APPLICATION NO.	FILING DATE	FIRST NAMED INVENTOR	ATTORNEY DOCKET NO.	CONFIRMATION NO.
10/764,571	01/27/2004	Alain Gauthier	713-1029	9023

Office Action Summary	Application No. 10764,571	Applicant(s) GAUTHIER, ALAIN	
	Examiner David C. Reese	Art Unit 3677

THIS FINAL ACTION IS RESPONSIVE TO THE AMENDMENT FILED 4/24/2006.

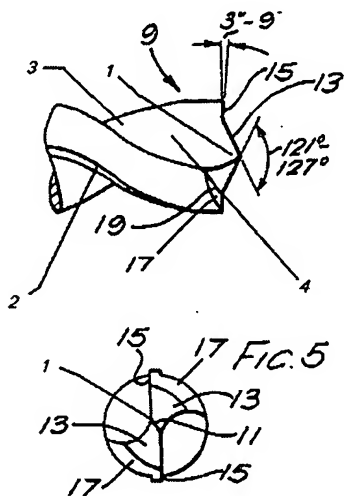
Mulroy et al. discloses a drilling portion similar to that of West et al. In addition, Mulroy et al. further teaches of each of flutes (3 in the Figure below) opening onto a flat surface (4) forming the walls of both a central drilling tooth (1) and one of two lateral drilling teeth (15). It would have been obvious to one of ordinary skill in the art, having the disclosures of West et al. and Mulroy et al. before him at the time the invention was made, to modify the drilling portion of West et al. to have the flat surface of the flute opening form the walls of both a central drilling tooth and one of two lateral drilling teeth as in Mulroy et al. One would have been motivated to

Mulroy et al. discloses a drilling portion similar to that of West et al. In addition, Mulroy et al. further teaches of each of said flutes (3 in Figure above) opening onto a flat surface (4) forming the wall of a central drilling tooth (1) and of one of two lateral drilling teeth (15). Further, Mulroy et al. discloses wherein said drilling portion further comprises two lateral drilling teeth (15) on opposite sides of said central drilling tooth (1), each of said lateral drilling teeth (15) having a flat surface being coplanar with one of the flat surfaces of said central drilling tooth (1).

Mulroy et al. discloses a drilling portion similar to that of West et al. In addition, Mulroy et al. further teaches of each of said flutes (3 in figure above) opening onto a flat surface (4) forming the wall of a central drilling tooth (1) and of one of two lateral drilling teeth (15).

Further, Mulroy et al. discloses wherein said drilling portion further comprises two lateral drilling teeth (15) on opposite sides of said central drilling tooth (1), each of said lateral drilling teeth (15) having a flat surface which is a continuous extension of one of the flat surfaces of said central drilling tooth (1), and which extends seamlessly without interruption into said one of the flat surfaces of said central drilling tooth (1).

Re: Claim 21, Mulroy et al. discloses wherein an angle between said walls is zero (the angle between 1 and 15 in the second figure, figure 5, above).
